Access Compliance Report

Public Rights-of-Way

Intersection ID: 43669	Main Street: CORSICA_FOREST_DR	Cross Street: ASHETON_CREEK_DR	Location: S
ADA ID: 7966BB268591	Ramp Type: PerpDiag	Initial Pass/Fail: Fail	Overall Compliance: No
Severity Score: 10			
Codes/Mitigation Info/Possible Solution		Field Measurements/Component Compliance

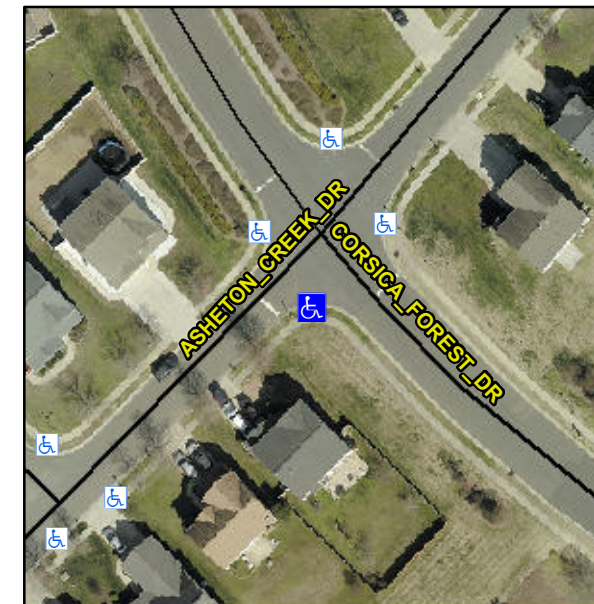
R304.5.1, R304.5.3

Compliance	Description	Data	Compliance	Description	Data
N/A	Ramp Length (in)	48.0	Yes	Ramp Slope (%)	6.3
No	Ramp Width (in)	41.0	No	Ramp XSlope (%)	2.5
N/A	Flare Type LT	N/A	N/A	Flare Type RT	N/A
N/A	Flare Slope LT (%)	N/A	N/A	Flare Slope RT (%)	N/A
N/A	Flare Traversable LT?	N/A	N/A	Flare Traversable RT?	N/A
N/A	Landing Length (in)	N/A	N/A	DWS Provided?	N/A
N/A	Landing Width (in)	N/A	N/A	DWS Contrast?	N/A
N/A	Landing Slope (%)	N/A	N/A	DWS Length (in)	N/A
N/A	Landing X Slope (%)	N/A	N/A	DWS Full Width?	N/A
N/A	Landing Curb? (Y/N)	N/A	N/A	DWS Offset (in)	N/A
N/A	Shared Landing?	N/A			
N/A	Gutter Ponding?	N/A	N/A	Gutter Slope (%)	N/A
N/A	Gutter Lip Ht (in)	N/A	N/A	Gutter X Slope (%)	N/A
N/A	Painted X Walk1?	No	N/A	Painted X Walk2?	No
	X Walk 1 Direction	To NE		X Walk 2 Direction	To NW
N/A	X Walk 1 Width (in)	N/A	N/A	X Walk 2 Width (in)	N/A
	X Walk 1 Slope (%)	3.9		X Walk 2 Slope (%)	0.3
	X Walk 1 X Slope (%)	1.7		X Walk 2 X Slope (%)	2.3

Remove & Replace Curb Ramp With Two New Directional Ramps or Equivalent.
